Subject ▶ Addition of rubber ring 19

For Models ▶ 4304 and 4305 (Jig Saw)

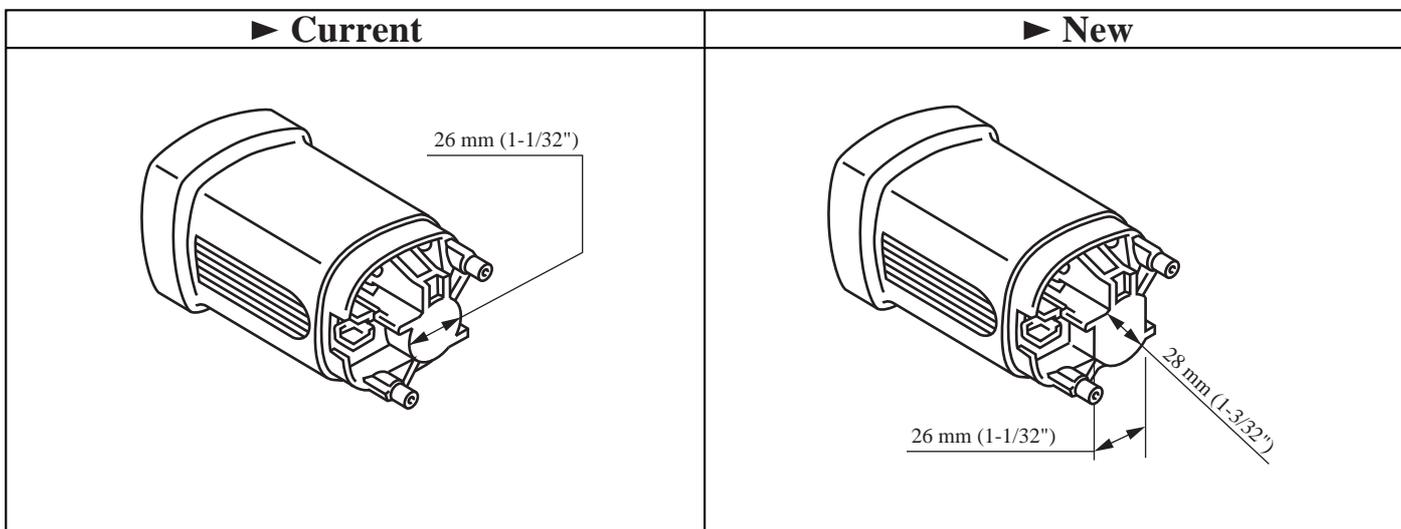
Description ▶ 1. A rubber ring 19 (with labyrinth construction) will be added.

2. Re: Motor housing

The portion to accept the ball bearing will be changed in dimension as follows.

Current	New
Inner diameter	19 mm (3/4")	22 mm (7/8")
Outer diameter	26 mm (1-1/32")	28 mm (1-3/32")
